To: SCL File No: 4223022-m-e-c002.docx  
Attention: WBOPDC  
From: Stephen Bos  
Date: 11 May 2023  
Subject: Tinex Group Ltd – 245 Te Puna Station Road –  
Stormwater Queries

### STORMWATER MANAGEMENT

**Existing Site Plan**  
**Lot 2 DP 22158**

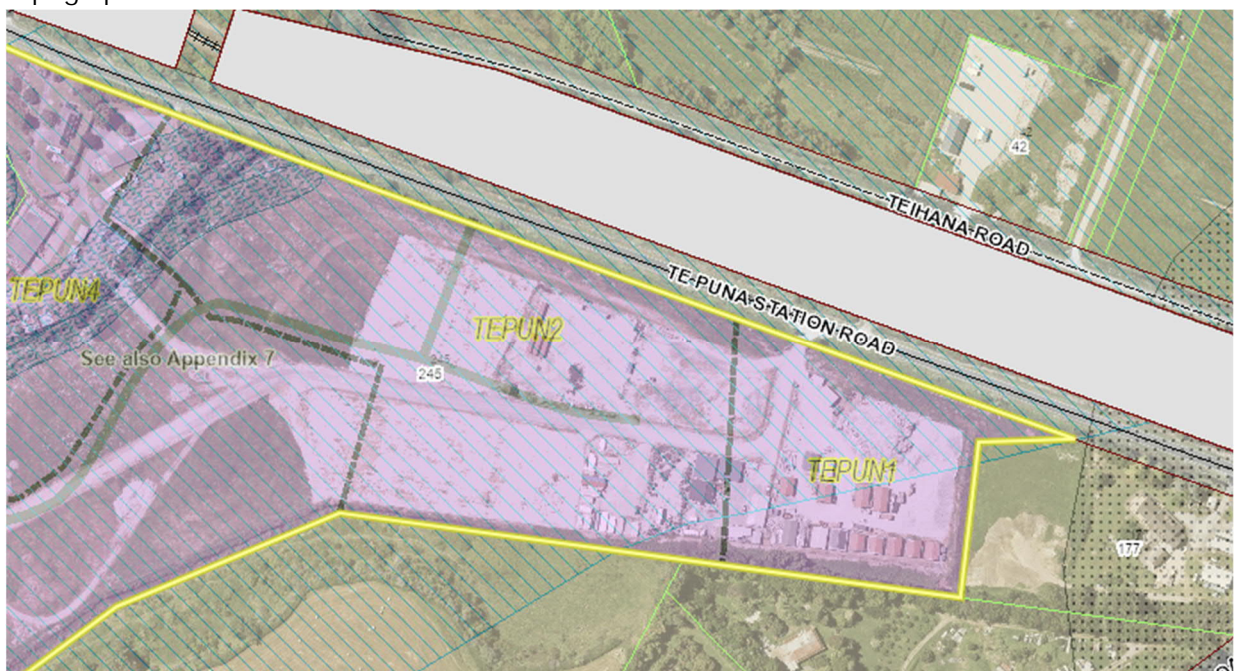
1. The stormwater assessment provided is lacking in technical evidence. Please provide:
  - a) calculations to demonstrate that the stormwater impact from the current users on the overall catchment is minimal.
  - b) Topographic Plans showing the existing land contours/spot heights, and overland flow paths.
  - c) Additional information that further qualifies the statement that *"from the discharge location, the flows disperse across the full site area such that mitigation of the additional flow is considered to occur prior to exiting the individual yard site"*.

The site is currently zoned Industrial, and the site lies within the Te Puna Industrial Park, with layout as below. A detailed site survey of the area is attached to this response that shows the layout and topographical details of the site.
